Device **TC29x**
Marking/Step **ES-BC, BC**
Package **see Data Sheet**

This Errata Sheet describes the deviations from the current user documentation.

Table 1 Current Documentation¹⁾

Figure 1 Message buffer transfer from Message RAM to OBF

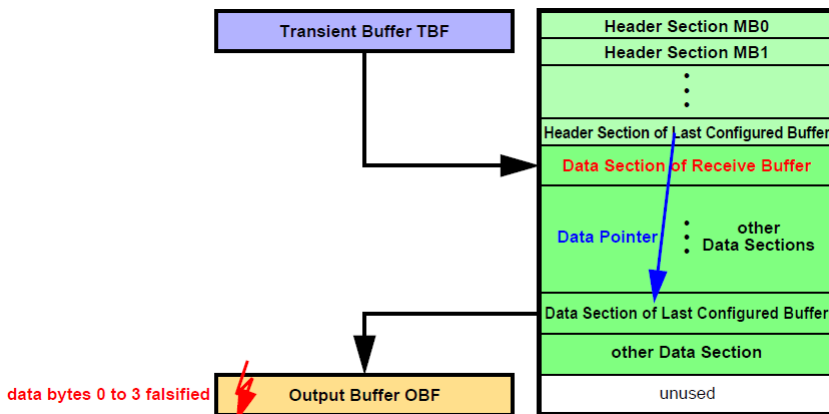
When the message buffer has its payload configured to maximum length (PLC = 127), the OBF word on address 00h (payload data bytes 0 to 3) is overwritten with unexpected data at the end of the transfer.

Figure 2 Message buffer transfer from IBF to Message RAM

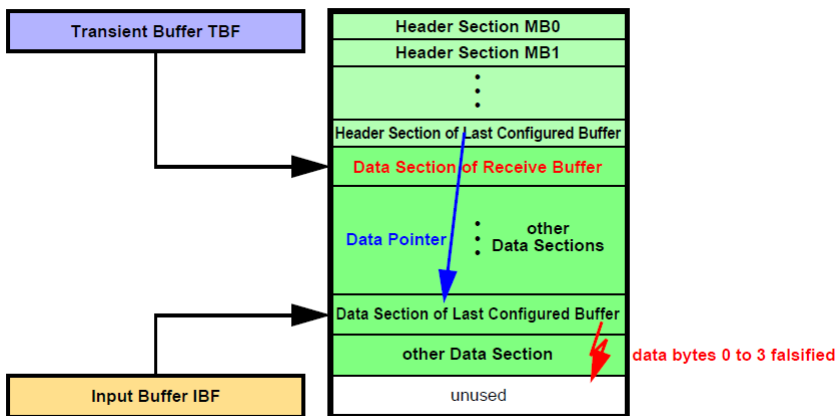
After the Data Section of the selected message buffer in the Message RAM has been written, one additional write access overwrites the following word in the Message RAM which might be the first word of the next Data Section.

Figure 3 Message RAM Configurations

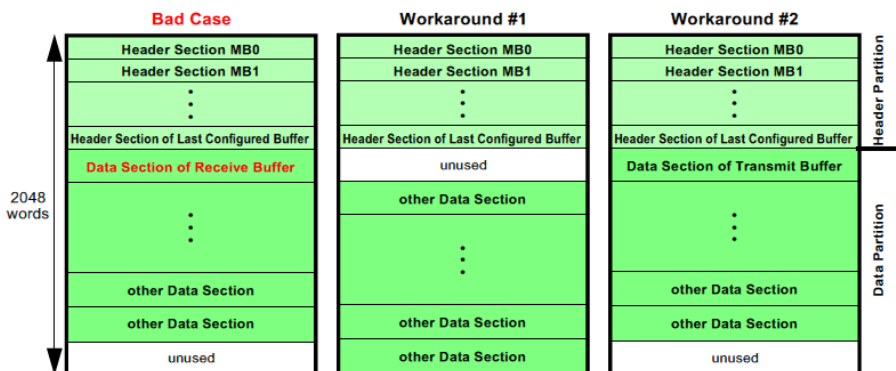
The erratum is limited to the case when (see [Figure 3](#) “Bad Case”):

- a) When a message is transferred from the Last Configured Buffer in the Message RAM to the OBF and **PLC = 127** it may happen, that at the end of the transfer the OBF word on address 00h (payload data bytes 0 to 3) is overwritten with unexpected data (see [Figure 1](#)).
- b) When a message is transferred from IBF to the Last Configured Buffer in the Message RAM, it may happen, that at the end of the transfer of the Data Section one additional write access overwrites the following word, which may be the first word of another message's Data Section in the Message RAM (see [Figure 2](#)).

2) Ensure that the Data Section directly following the Header Partition is assigned to a transmit buffer.

Figure 13 SENSE Tolerance of this Design Step

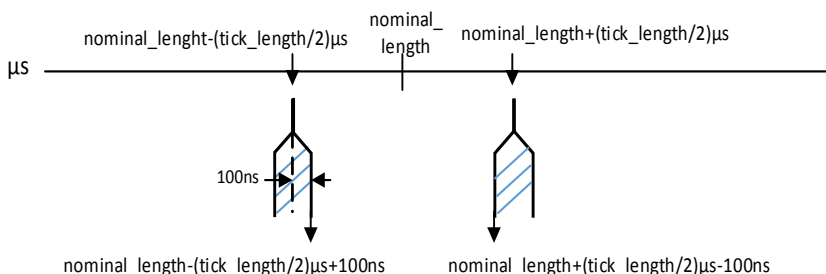
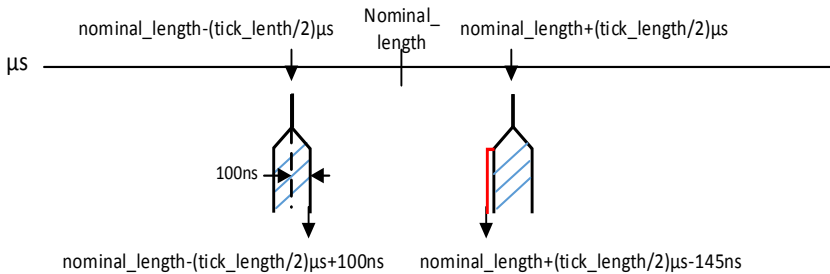
In this design step the range is delimited as follows:

- The lower border is $\text{nominal_value} - (\text{tick_length}/2) \mu\text{s} + 100 \text{ ns}$
- The upper border is $\text{nominal_value} + (\text{tick_length}/2) \mu\text{s} - 145 \text{ ns}$.

Recommendation

Figure 14 Short Serial Message, Serial Data Encoding over 16

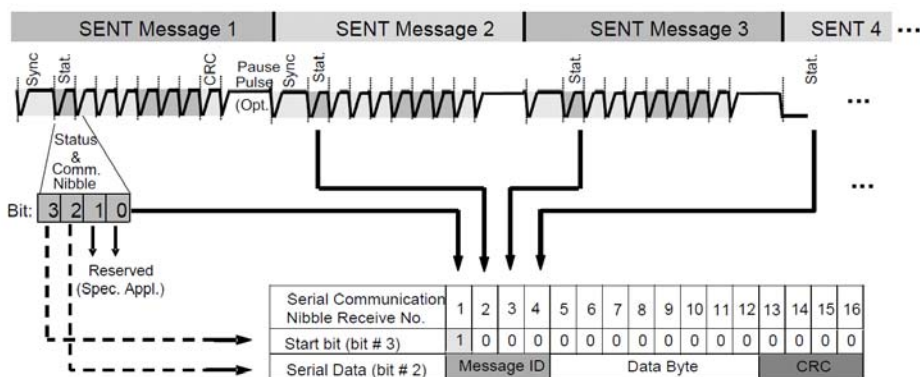
In Figure “Short Serial Message, Serial Data Encoding over 16 messages” of the SENT chapter, the arrows originating from bits 2 and 3 of the Status & Comm Nibble are routed incorrectly and must be swapped.

Figure 14 shows a corrected version of this figure.
